B I D A D D E N D U M 0 6

ORANGE ULSTER BOCES

ADDITIONS & ALTERATIONS TO EMANUEL AXELROD SPECIAL EDUCATION CENTER

**OVERALL 1ST
FLOOR DEMO
PLAN**

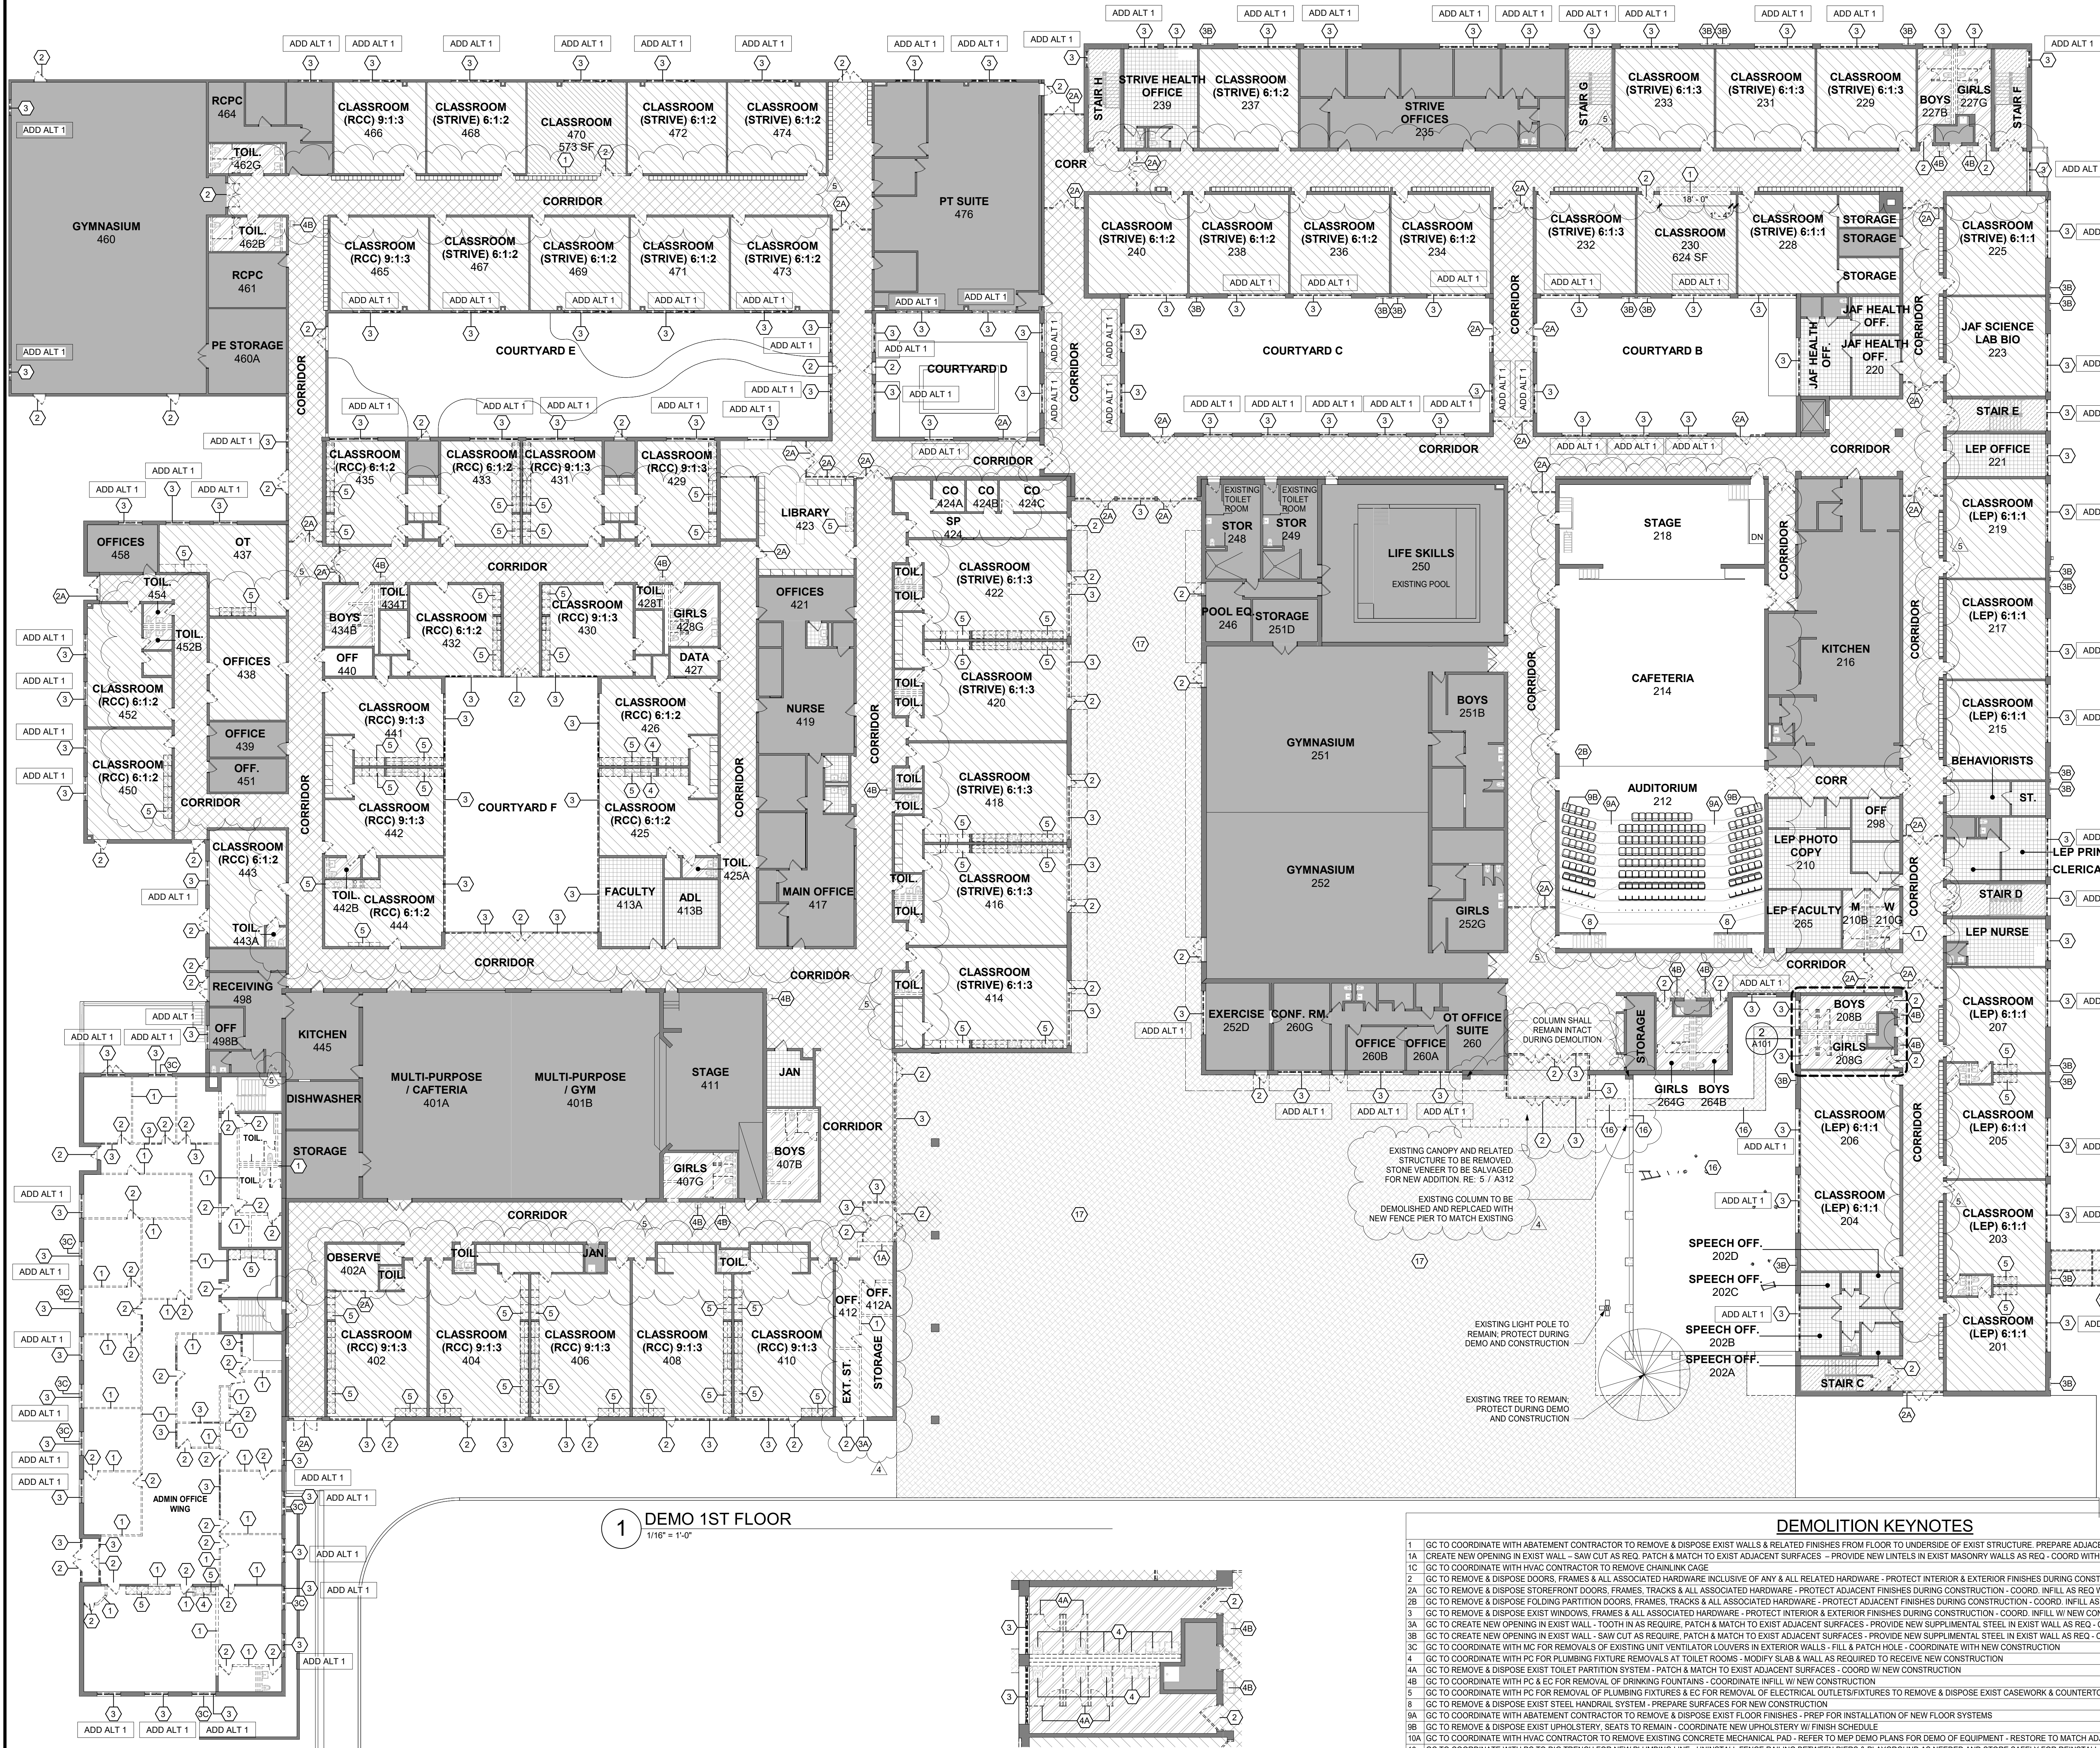
- 4.1 A101 – Overall 1st Floor Demo Plan
 - a. See REVISED plan with note 2C removed.

- 7.42 RFI Question – Sheet A101 includes a tag “2C”, which calls for the removal of existing doors and replacement with new doors (e.g., Room #203). However, new doors are not indicated on Sheet A201A or on the door schedule on Sheet A906. Please confirm if the locations tagged as “2C” will not receive new doors or provide updated drawings/specifications if replacements are required.

RFI Response – Sheet A101 is incorrect. See revised Sheet A101. Construction plans A200s and door schedule on Sheet A906 are correct.

ROOF PLAN

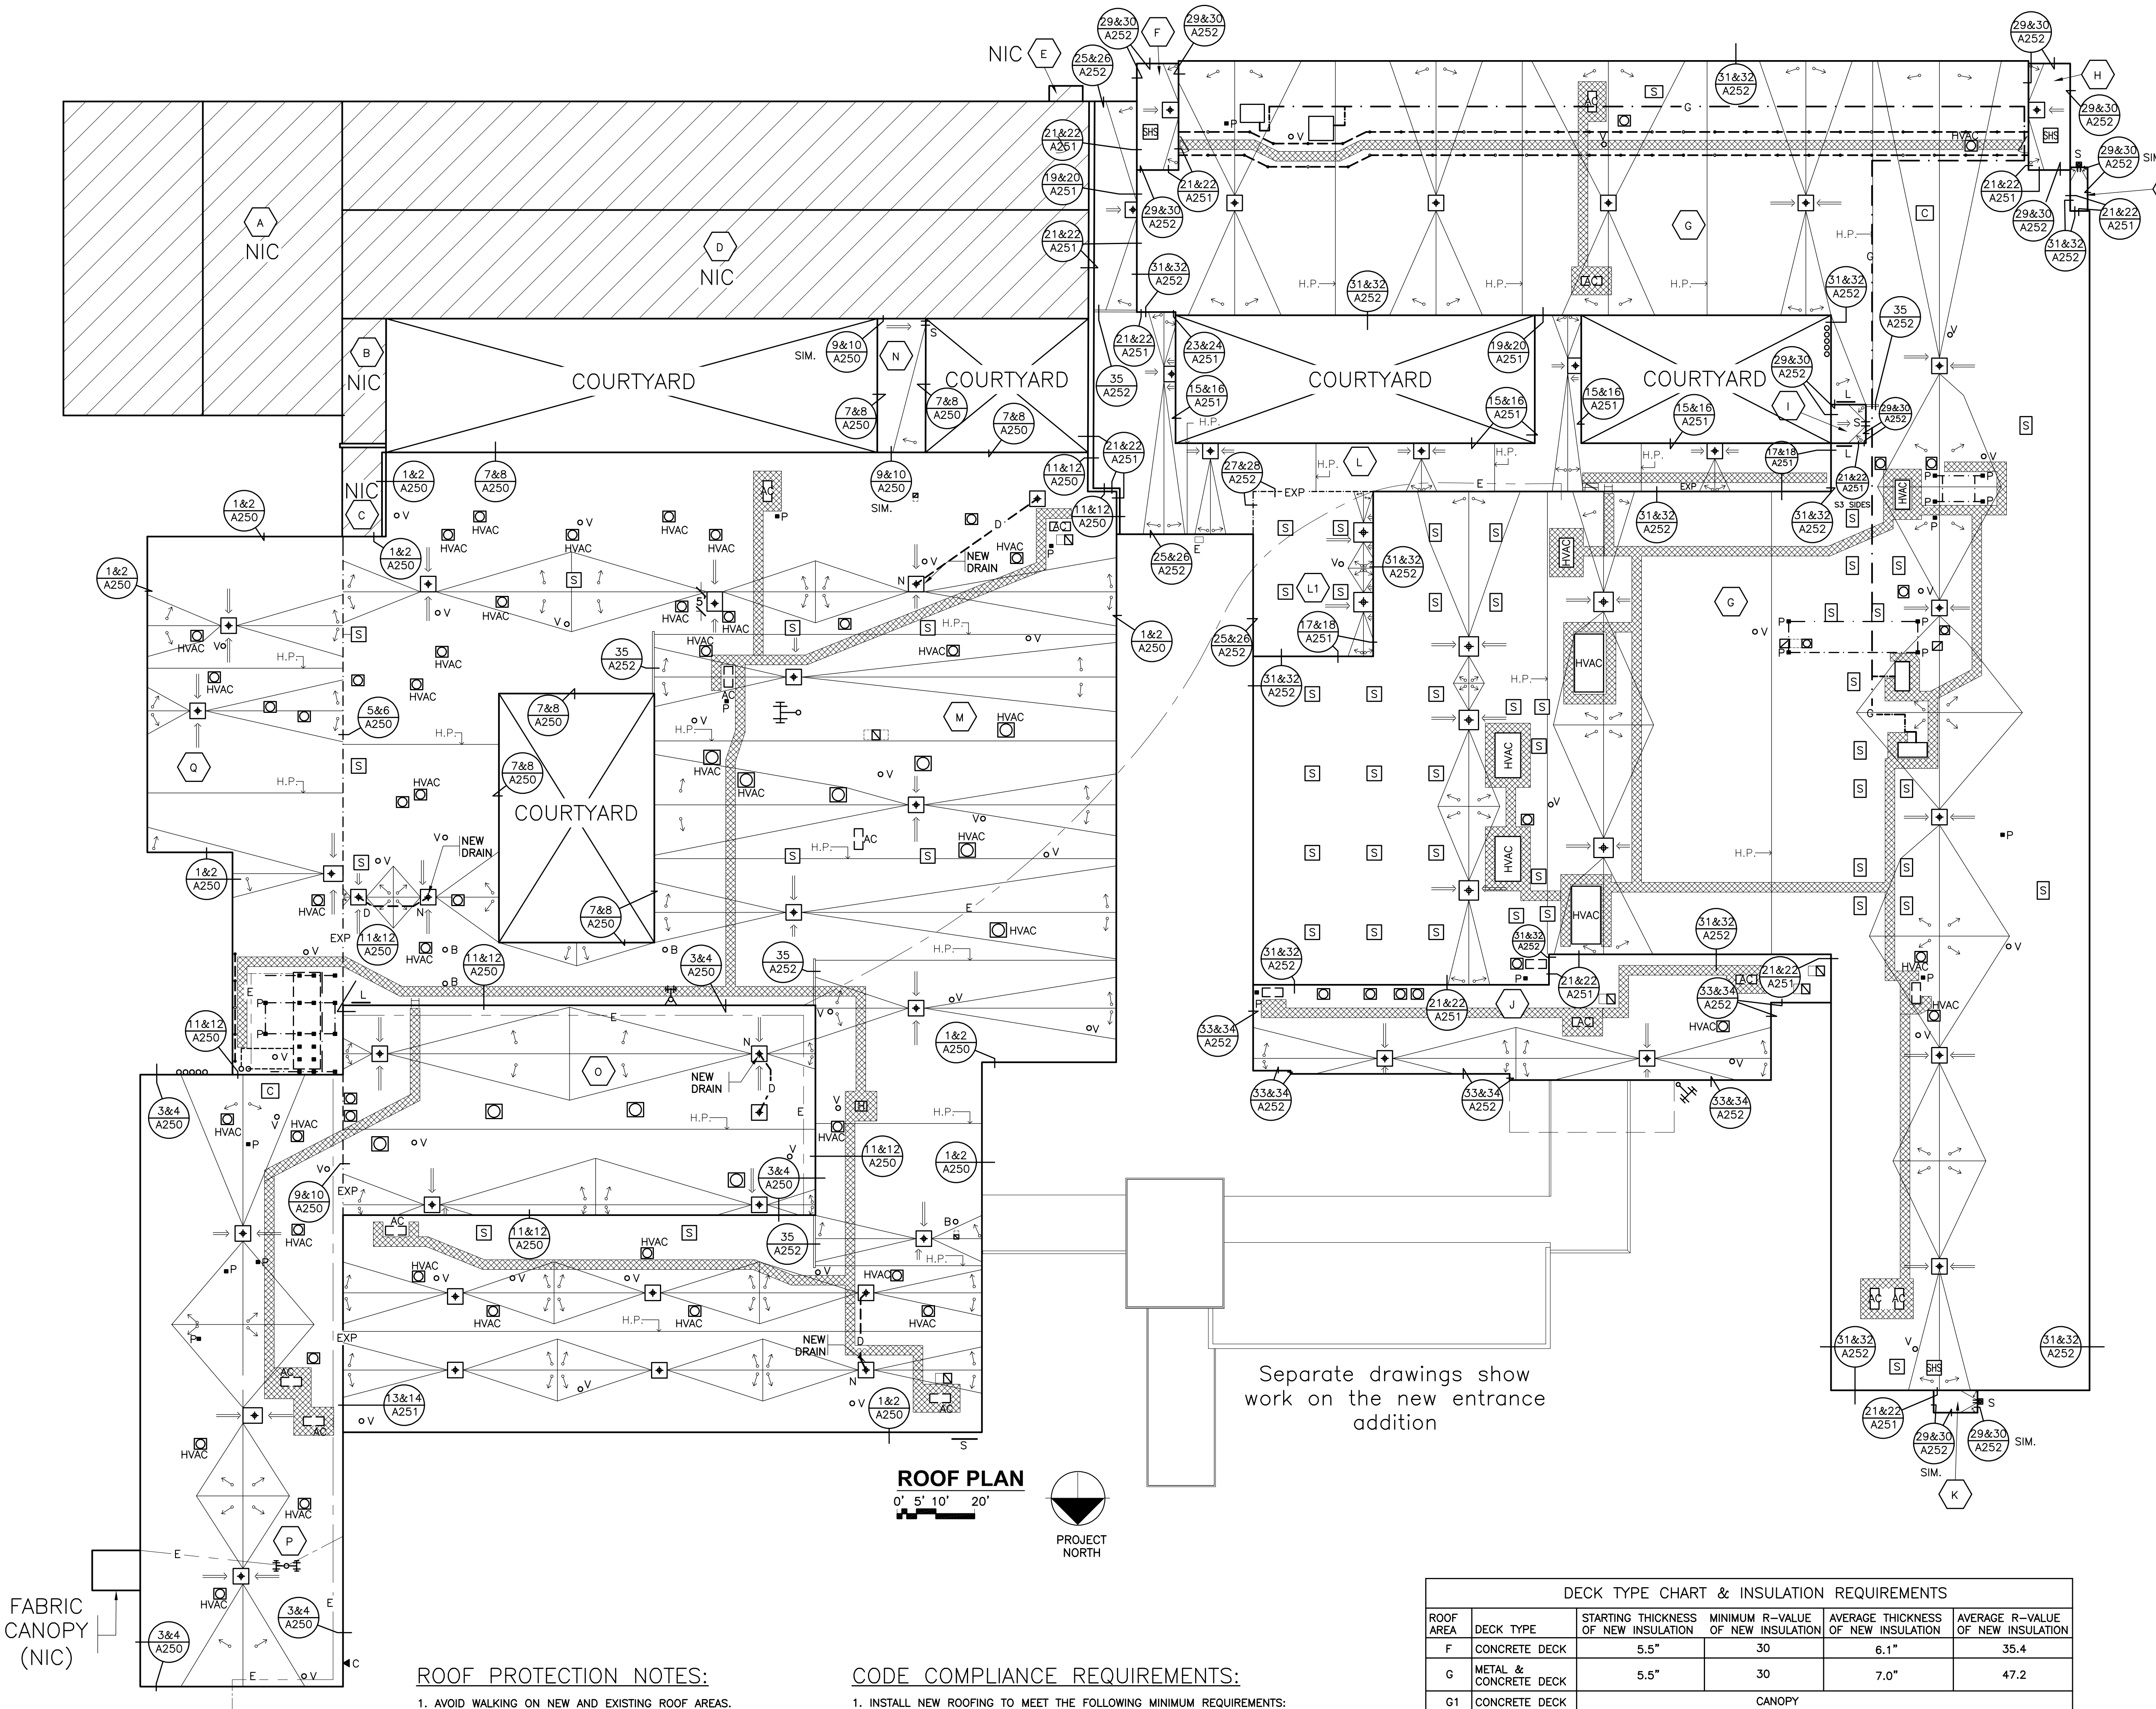
- 4.2 A102 – Ground & 2nd Floor Demo Plan
 a. See REVISED plans with note 2C removed.
- 4.3 A203 – Roof Plan
 a. See REVISED Roof Plan with new HVAC equipment shown
- 4.4 L954B – Landscape Elevations & Details – Alternate
 a. See added details regarding textured courtyard triangle pavers.

- 7.27 RFI Question - Which contract owns testing the roof drains per note 5 on A203?
RFI Response – The Plumbing Contract owns testing the roof drains.

- 7.28 RFI Question - Which contract owns removing & resetting lights fixtures per note 5 on A203?
RFI Response – The Roofing Contract owns removing & resetting light fixtures as pertains to notes on A203.

- 7.29 RFI Question – Which contract owns removing & resetting conduit & gas supports per note 8 on A203?
RFI Response – The Roofing Contract owns work pertaining to notes on A203.

- 7.30 RFI Question – Which contract owns the painting scope of work per note 9 on A203?
RFI Response – The Roofing Contract owns work pertaining to notes on A203.

- 7.34 RFI Question – Please confirm that note 14 on A203 is by the plumbing contract.
RFI Response – Confirmed. Plumbing Contract is to place drains including related insulation at undersides of new drain bowls.

- 7.36 RFI Question - What is being done at the abandoned roof drains shown on A203?
RFI Response – There are no roof drains to be abandoned. All existing roof drain locations will be replaced per detail 36/A252.

- 7.38 RFI Question – Note 6 on A203 says to set AC units on concrete pavers and walkway pads. M602 detail 8 shows new rail supports. Are the units being mounted on pavers per A203 or rails per M602? There's no roofing detail for rail support curbs shown on A250-A254.
RFI Response – Follow mechanical information for rail supports.
